## ORIGINATION FORM

### Proposed Revisions to a Standard Plans Index (Please provide all information — Incomplete forms will be returned)

Index Number: 102-625

Index Title: Temporary Road Closure - 5 Minutes or Less

INDEX  
102-625

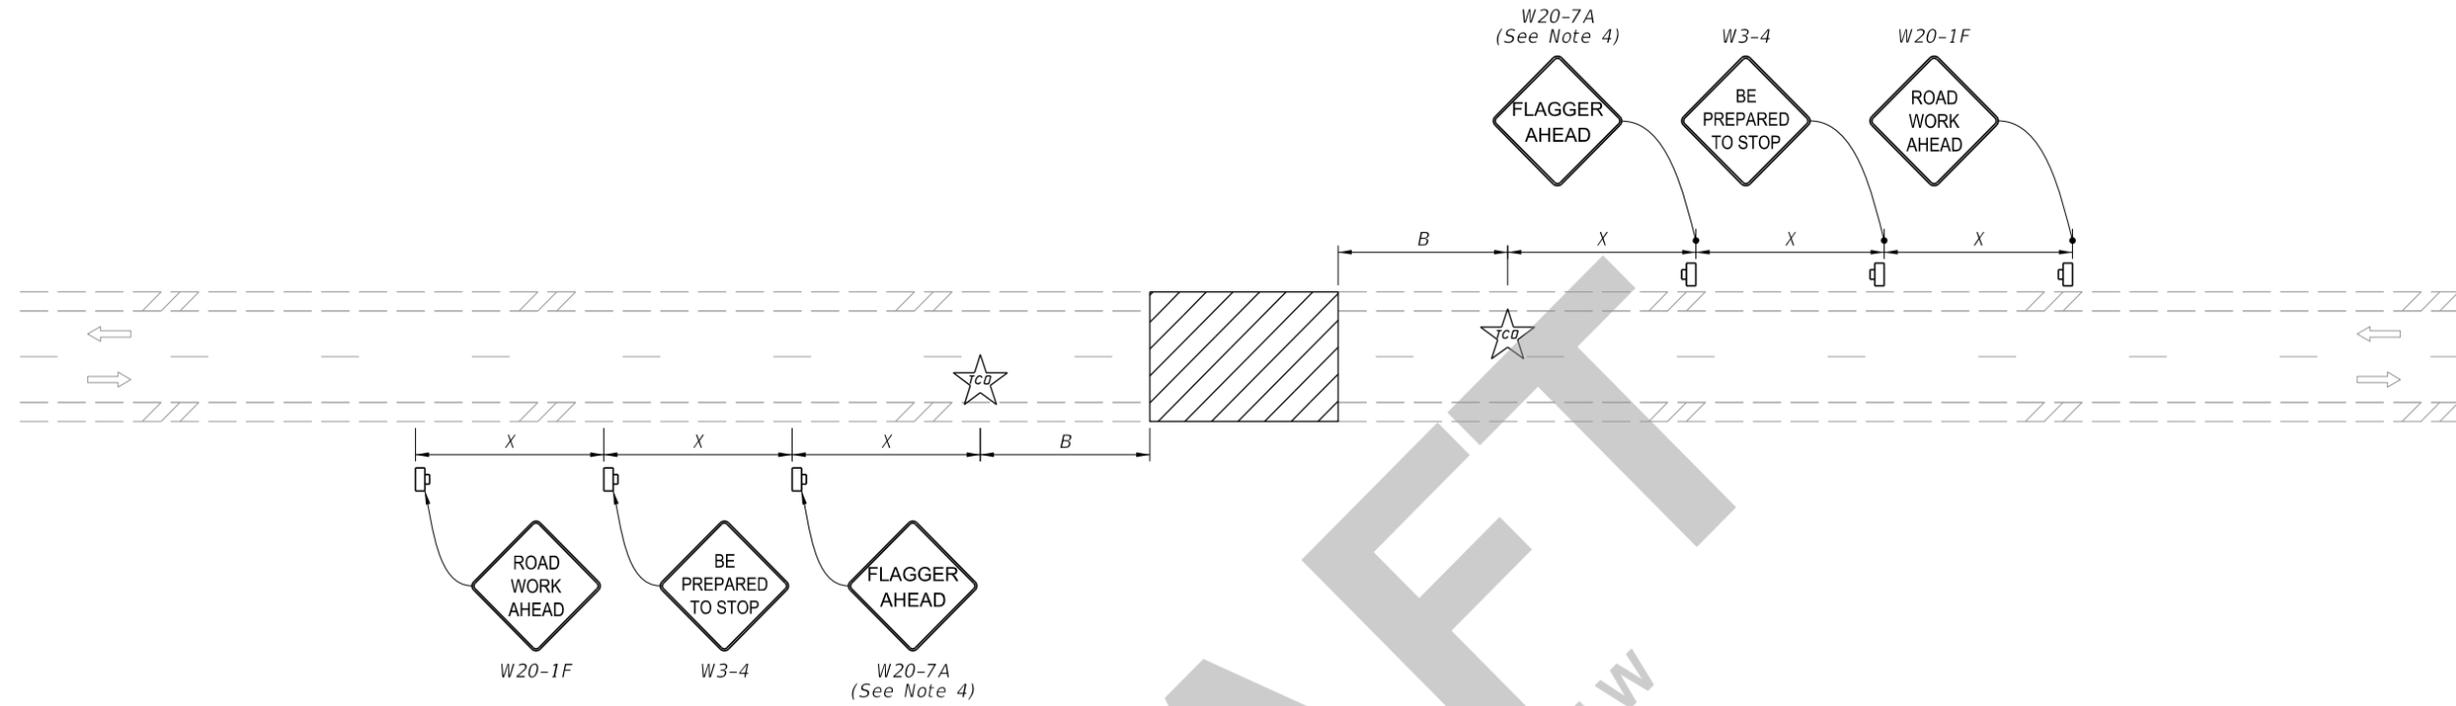
Sheet 1: Revised and Consolidated Details; Revised Notes; Deleted 'Buffer Space' and 'Distance Between Signs' Tables (Moved to 102-600); Deleted Conditions; Renamed Index.

DELETED - CONSOLIDATED AND MOVED TO 102-600

REVISED AND CONSOLIDATED DETAILS

REVISED NOTES

1. This Index applies to two-lane, two-way and multilane roadways, except limited access facilities with temporary daytime roadway closures of 5 minutes or less.
2. B=Buffer Length  
X=Work Zone Sign Distance

See Index 102-600 for "B" and "X" values.
3. Traffic volume or complexity of the roadway may dictate additional signs, devices or traffic control officers.
4. Optionally, use "Flagger Ahead" sign with symbol (W20-7) instead of "Flagger Ahead" sign with text (W20-7A).
